**Proposed Revisions
to the
MAC Frame Formats
to
Support Wireless Distribution Systems**

Abstract: This paper presents the changes to section 4 required to enable the use of 802.11 LANs as a distribution system for other 802.11 LANs sharing the same channel.

Action: Adopt the changes in this paper to replace the relevant portions of Section 4 of the current draft.

Figure 4-1: MAC Frame Format

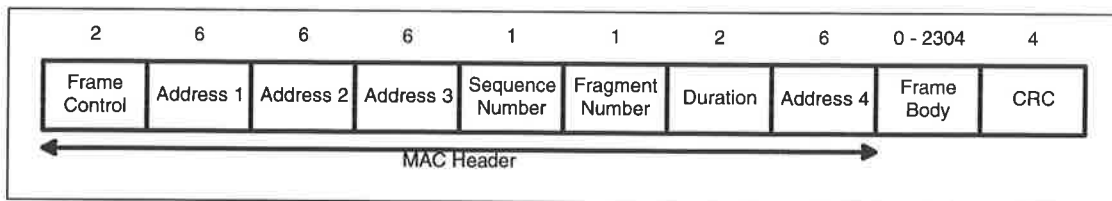
Figure 4-1 depicts the general MAC frame format and field order. The format of the MAC header for each of the frame types is defined subsequently. Following sections define each of the fields of the MAC header.

Figure 4-2: Frame Control Field

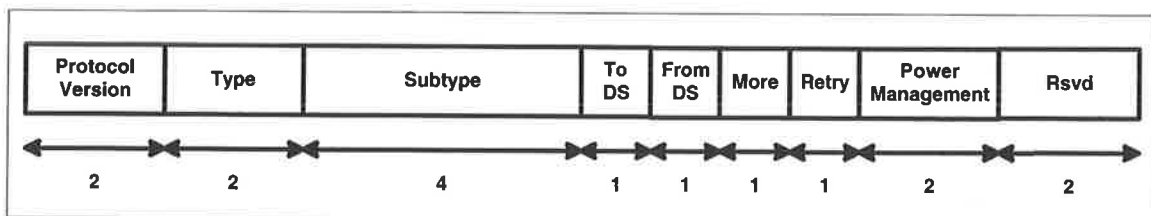
The Frame Control field shall consist of the following subfields: Protocol Version, Type, Subtype, To DS, From DS, More, Retry, and Power Management. The remaining subfields in the Frame Control field are reserved. All reserved bits and fields shall be sent as '0'. Reserved bits and fields shall be ignored on reception.

Figure 4-xx: RTS Frame

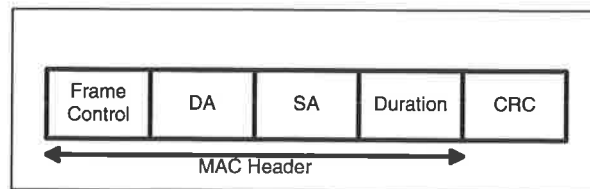
The DA of this frame shall be the address of the immediate station receiving the frame. In an infrastructure LAN, the DA shall be the address of the AP with which the station is associated. In an ad hoc LAN, the DA shall be the destination of the subsequent data or management frame. The SA shall be the address of the station transmitting the frame.

Figure 4-xx: Poll Frame

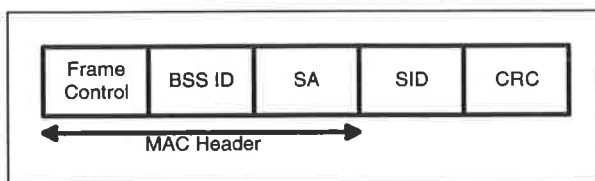
The BSSID shall be the address of the AP to which the Poll is directed. The SA shall be the address of the station transmitting the frame. The SID shall be the value assigned by the AP in the Associate Response frame.

Figure 4-xx: DATA Frame

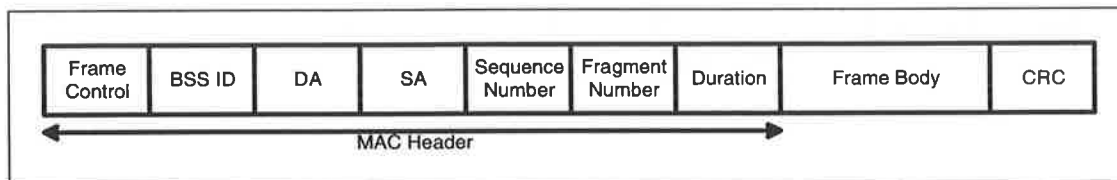
The BSSID of the Data frame shall be determined as follows:

- 1) If the station is an AP or is associated with an AP, the BSS Identifier shall be the address of the AP.
- 2) If the station is a member of an ad hoc LAN, the BSS Identifier shall be the BSS ID of the ad hoc LAN.

The DA shall be the destination of the frame, i.e. the destination of the MSDU.

The SA shall be the address of the station transmitting the frame.

The Frame Body shall be the MSDU or a fragment thereof.
